## Service Bulletin

No. 010

**Model:** TX-NR1000, DTR-10.5

**Subject:** Composite, S-Video picture is too bright.

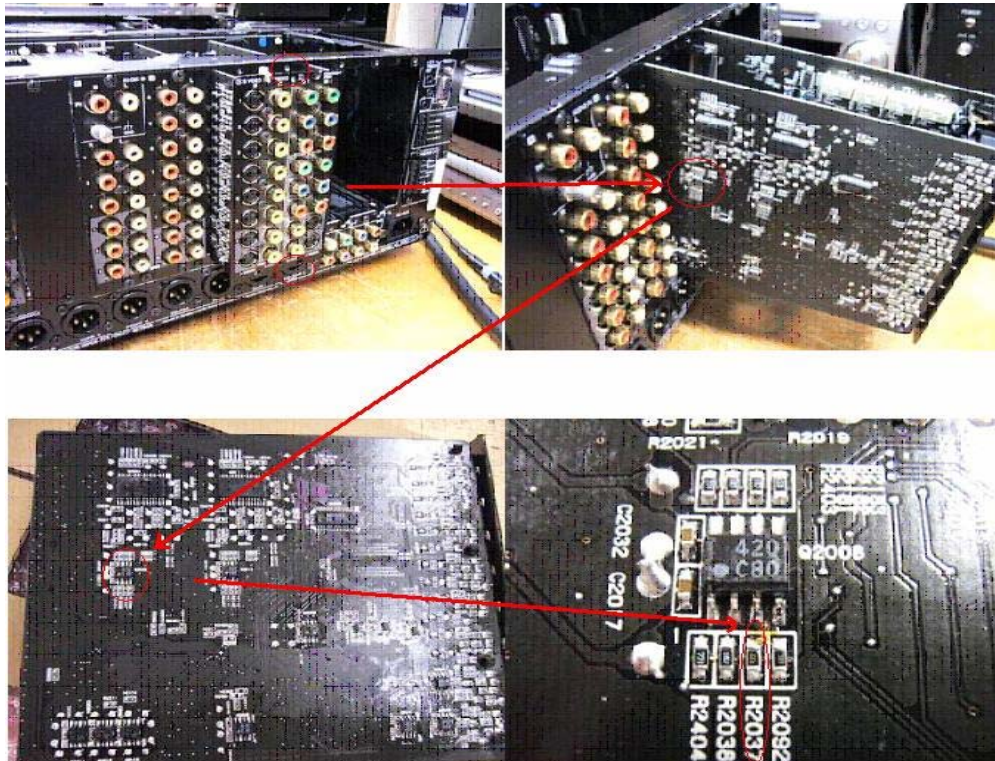
**Symptom:** The customer complains: When viewing a video source through the set the picture is too bright and washed out.

**Solution:** Replace resistor R2037, located on the NCVD-8201(C) plug in video board, with an 8.2K ohm resistor. **Note:** the resistor change only applies to the NCVD-8201(C) version video board. The NCVD-8201(B) board already has the correct value resistor.

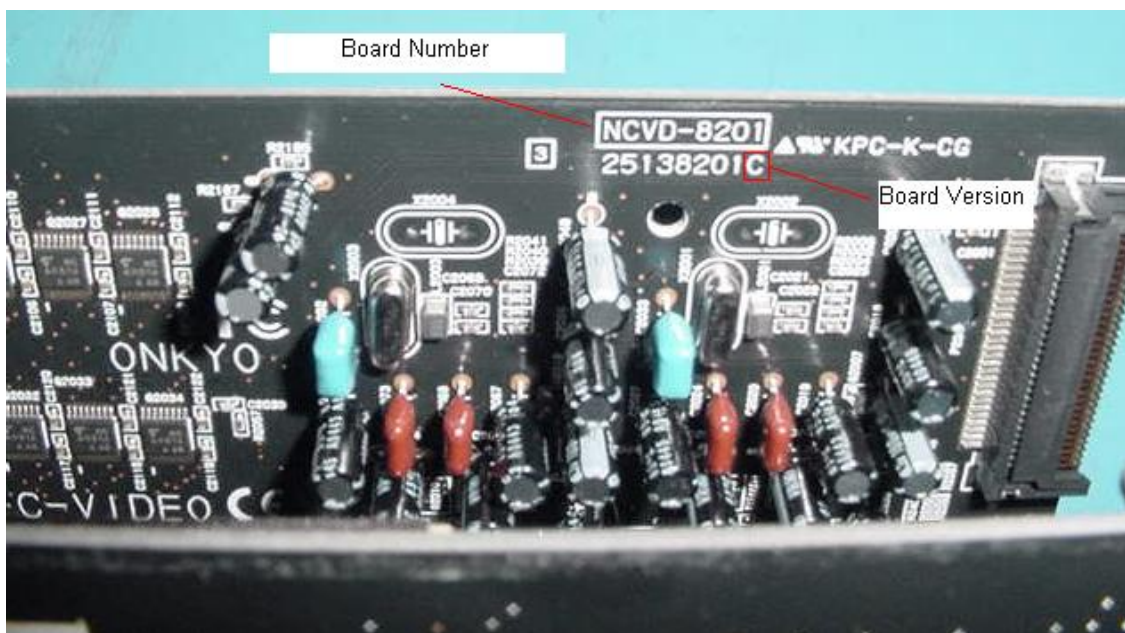
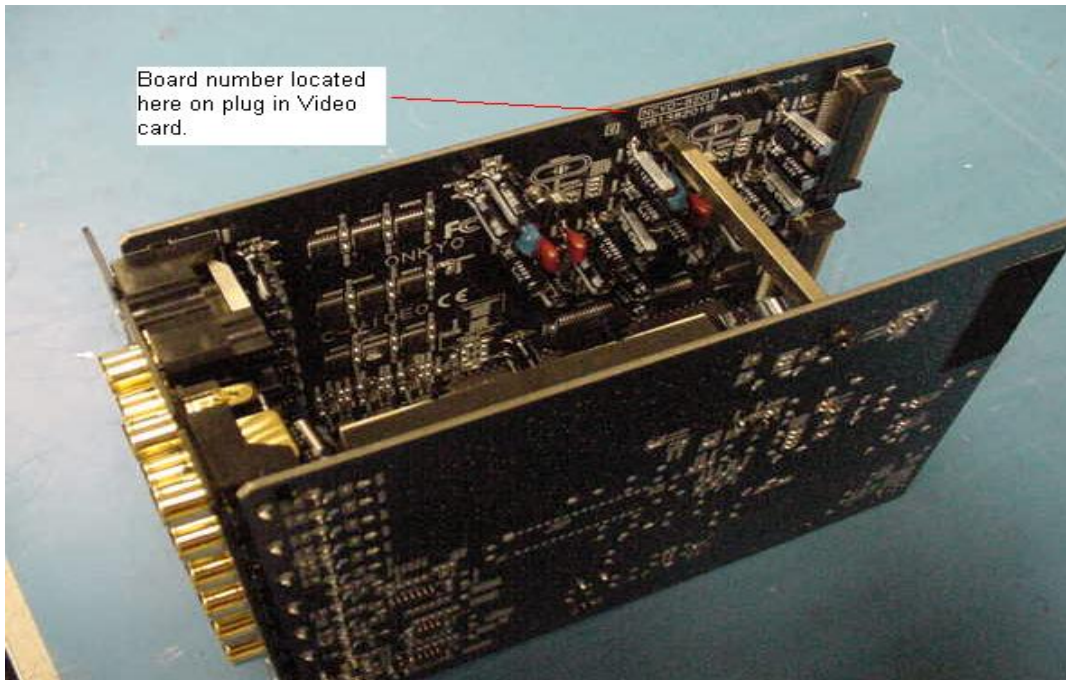
**Board Identification:** This update only applies to units having the plug in Video Board labeled NCVD-8201 (C). See photos to learn how to identify the video board type.
